**City Commission Consider  
Two Additional Conditions for Approval of  
Oaks Preserve Cluster Subdivision  
Design Plat  
Petition DB-18-17 SUB**

Legistar No. 171022

**Design Plat Review** for Oaks Preserve Cluster Residential Subdivision, to create 295 single-family residential lots on 95.17 acres. Located West of SW 50<sup>th</sup> Terrace, between SW Archer Road and SW 57<sup>th</sup> Avenue.

## Two Additional Conditions of Approval Petition DB-18-17 SUB

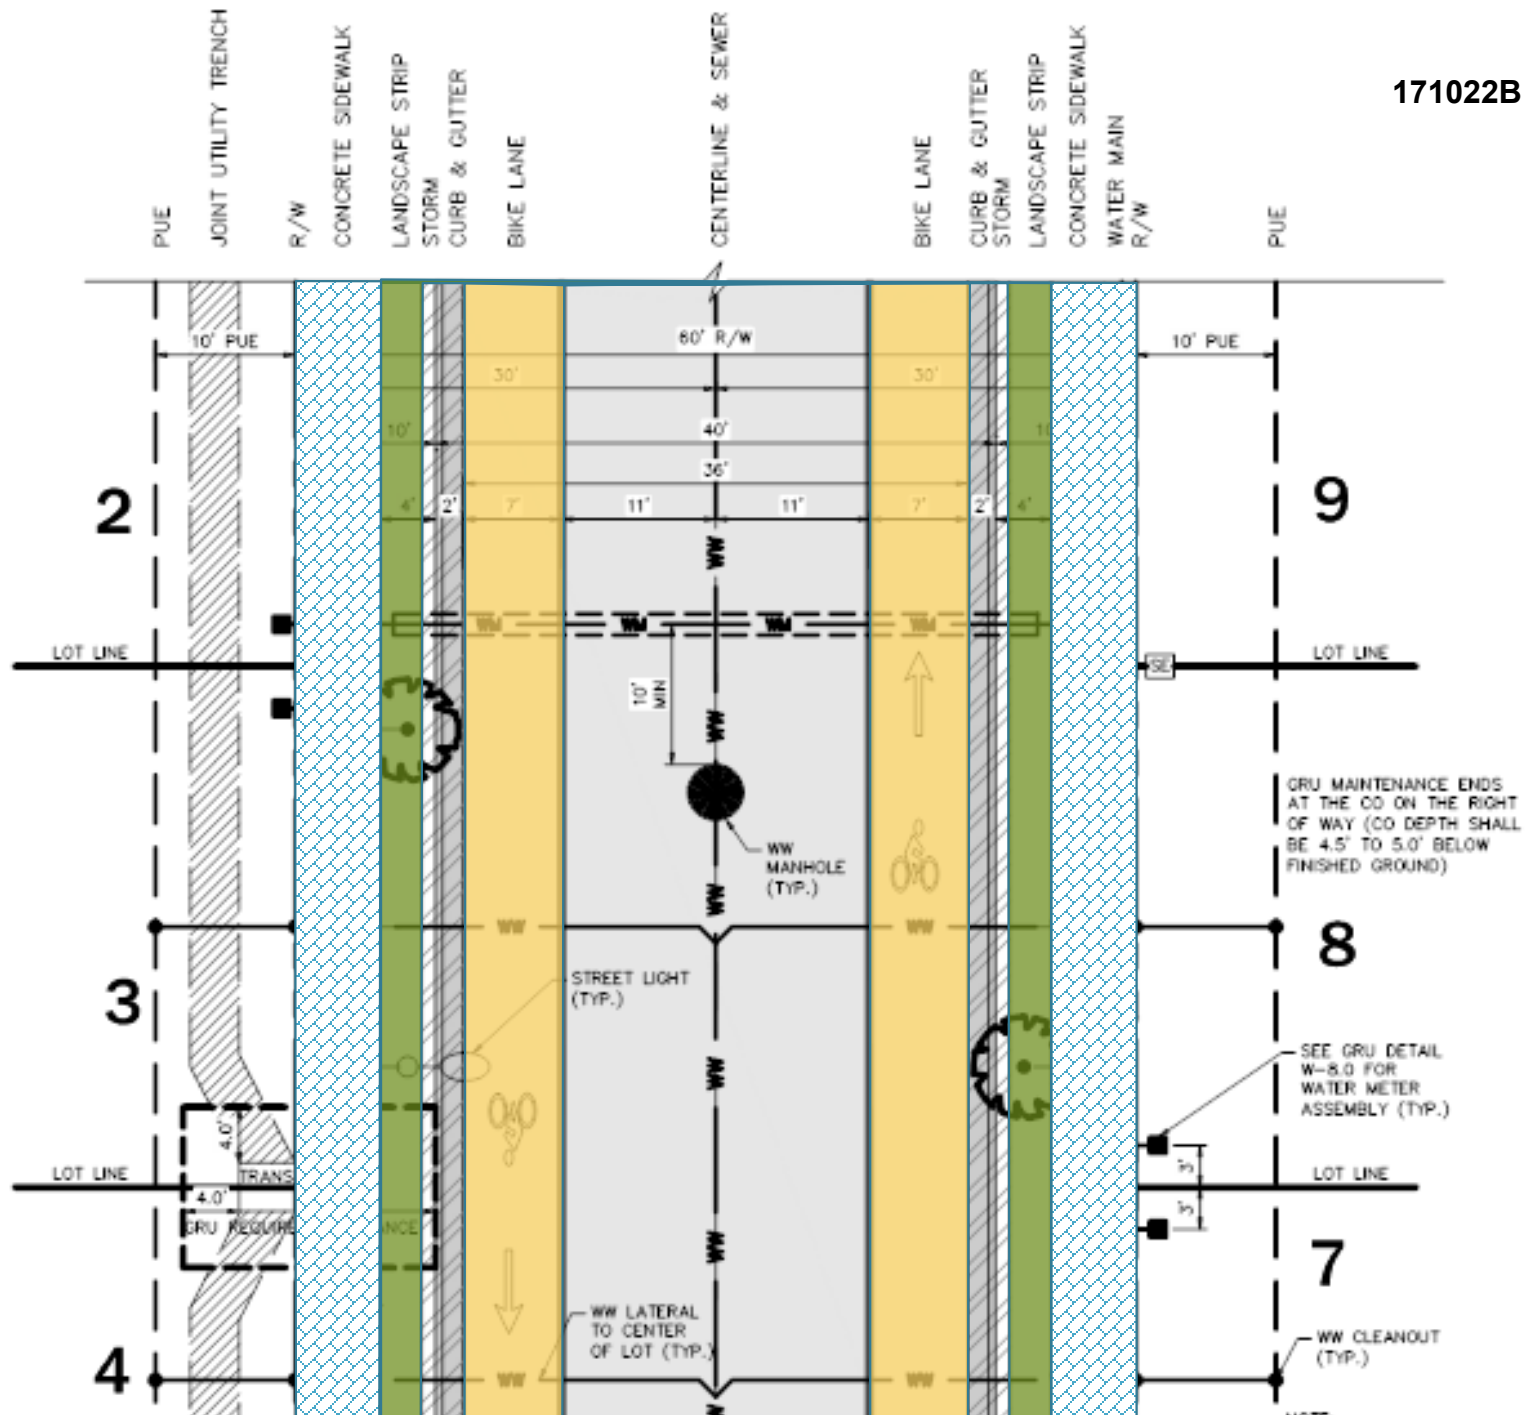
1. **The north/south trail: Design and Configuration**
2. **Width of right of way corridor between lots 135 and 136**
3. **Phasing of the subdivision**
4. **Modification of DRB Condition 14**
5. **A 7-foot wide buffered bike lane on Road “Q”;**

Prior to Construction Drawing approval, a final report shall be submitted indicating the status of the site relative to the occurrence of significant archeological artifacts. If the final report **may** requires modifications to the design plat to address archeological findings; additional review by the DRB and the City Commission **may** shall be required. **based-on-the-extent-of-any proposed redesign.**

**60' RIGHT-OF-WAY WITH BIKE LANE**  
**TYPICAL UTILITY ALLOCATION CROSS SECTION - SECTION F-F**  
 DESIGN SPEED: 35 MPH                      N.T.S.

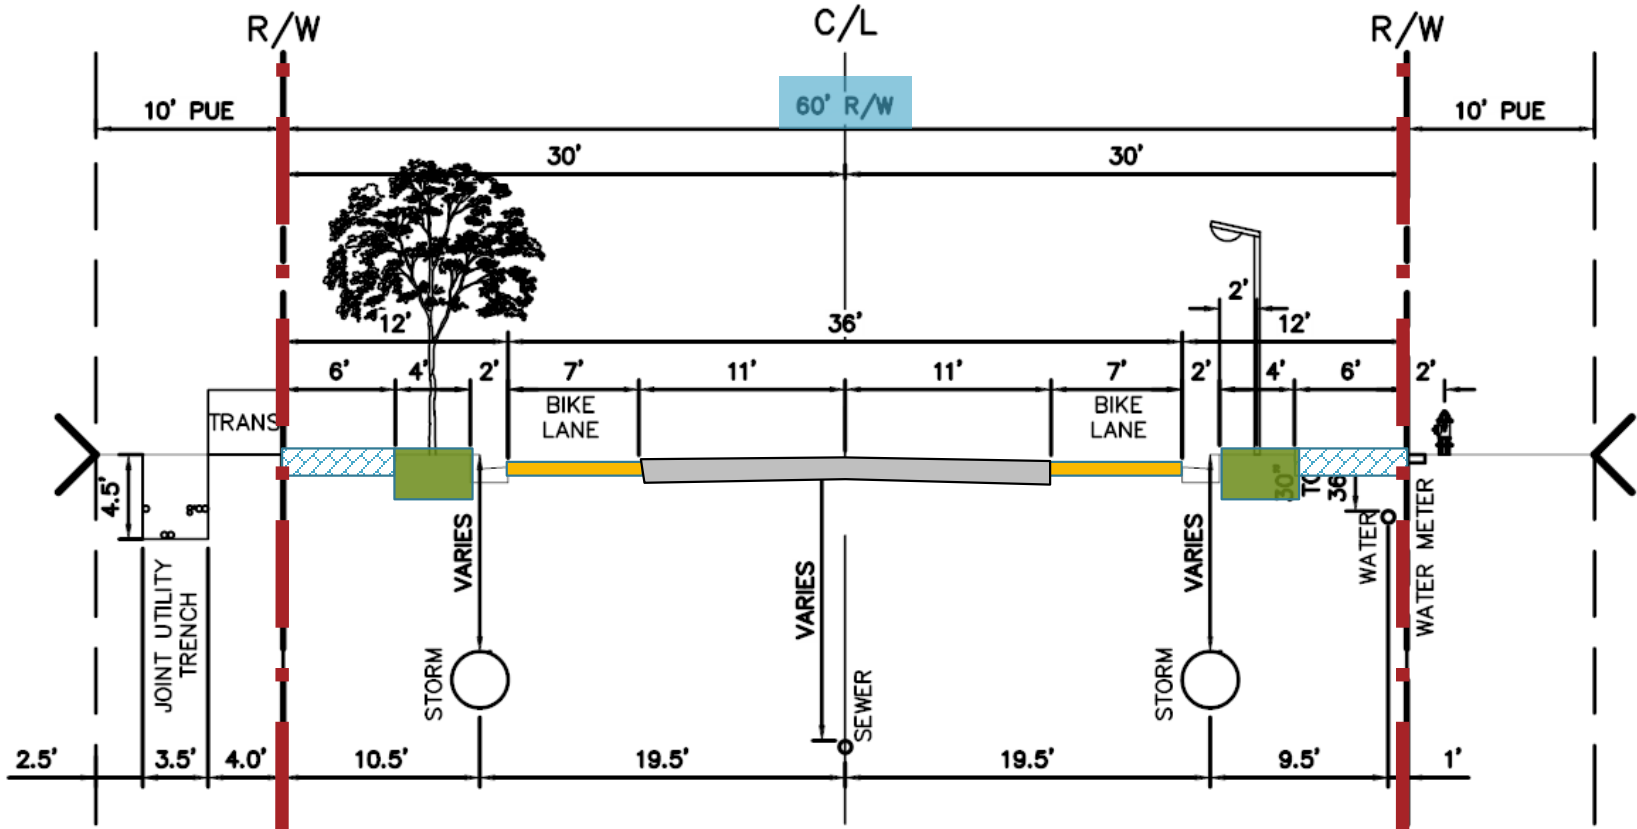
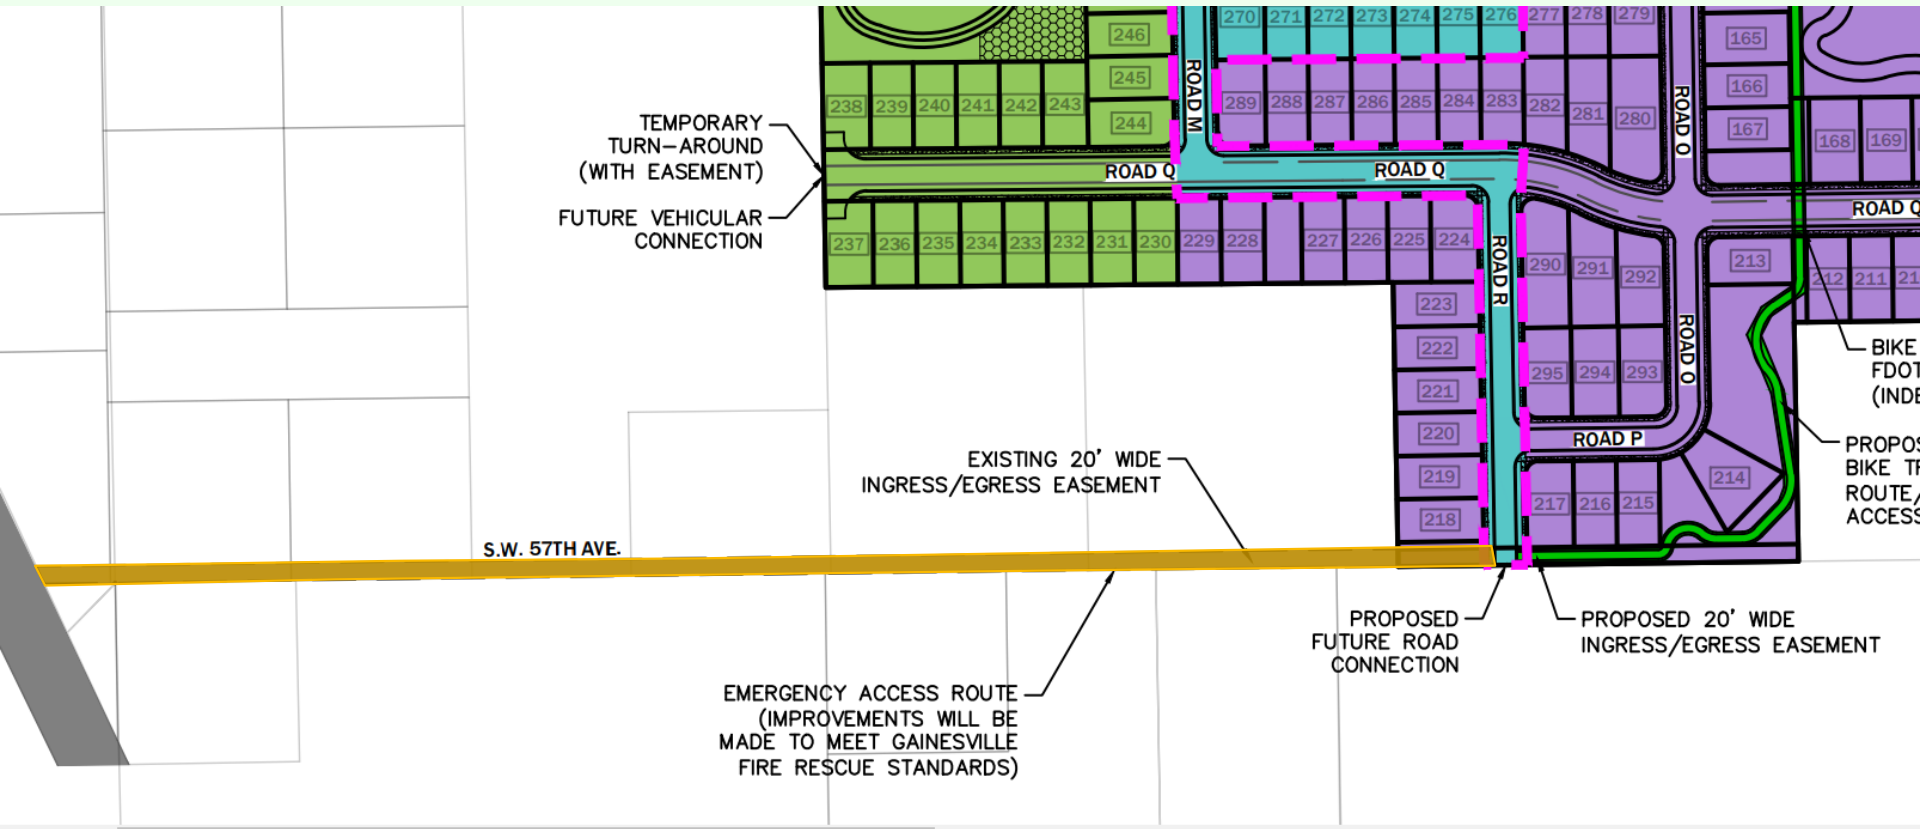
5. A 7-foot wide buffered bike lane shall be constructed on both sides of Road “Q”; the design shall be resubmitted to the City Commission for final approval.
